EXHIBIT H

From: [Avitabile, David](#)
To: ["Ndaw, Mamadou \(DCRA\)"](#)
Cc: ["Ilan Scharfstein"; Epting, John](#)
Subject: FW: 2121 M Street -- Review of our discussion
Date: Friday, November 22, 2013 12:20:04 PM
Attachments: [2121M Roof Plan.pdf](#)

ROOF TERRACE

HYATT PLACE HOTEL

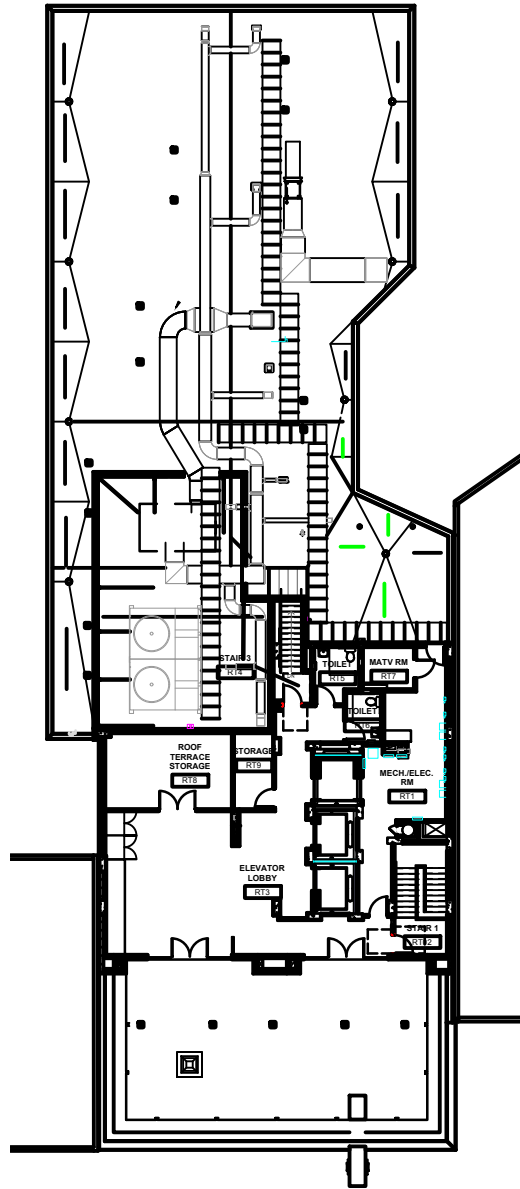
- 1- Do you have an image of the entire roof and the structures on it?
- 2- What is the percentage of the accessory interior rooftop penthouse space compared to the outdoor roof area that it serves?

- As we discussed, the proposed Project contains a roof structure that is set back from all exterior walls (that is, the south wall that faces M Street and the north wall that faces the open court). No setback is required from the east wall, which is a lot line wall that abuts another 90-foot tall building, or from the west wall, which faces a closed court within the single record lot.
- Pursuant to our discussion, we have modified the roof structure to reduce the amount of accessory space within the structure and clarify that the enclosed space is intended to be used for uses that are accessory to the rooftop recreation space , as shown on the attached plan. Please confirm that the revised roof plan is acceptable.

Thanks for the clarification, as well as illustrative plans that were attached to your email. By this email I am confirming my agreement with its analysis, and its conclusion that the areas of the rooftop structure comply with Section 411 of the Zoning Regulations.

ROOF TERRACE

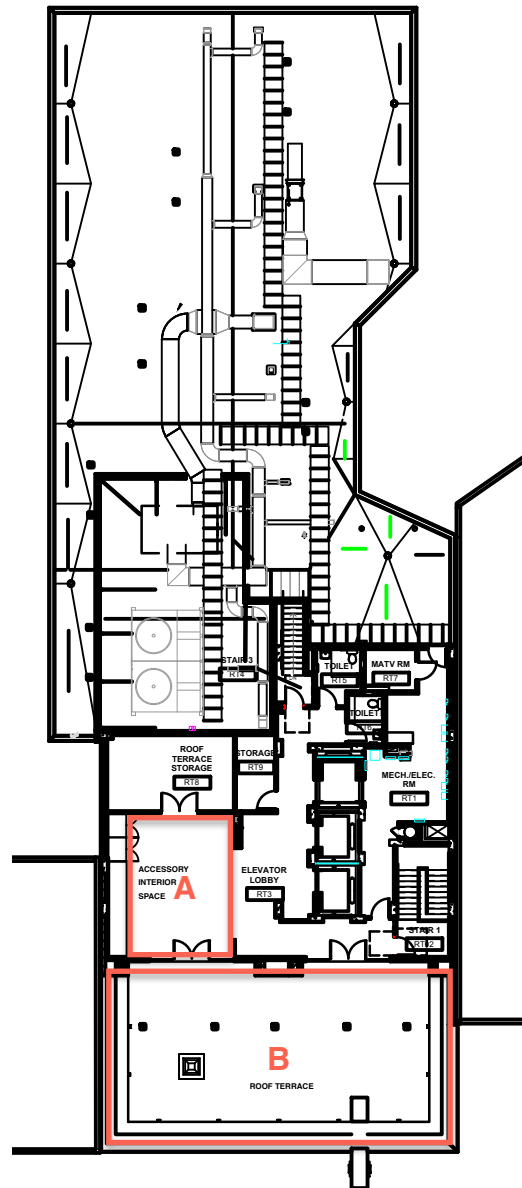
Please see attached for the whole roof plan and then a second page outlining the outdoor terrace and the interior accessory space. The outdoor terrace (B) is 1,687 s.f., and the interior space (A) is 480 s.f. This means that the interior space is 28-29% of the exterior space – however, our client noted that this is a function of the lot size and building configuration, which limits the size of the exterior space. In the absolute, the 480 s.f. interior space is small.
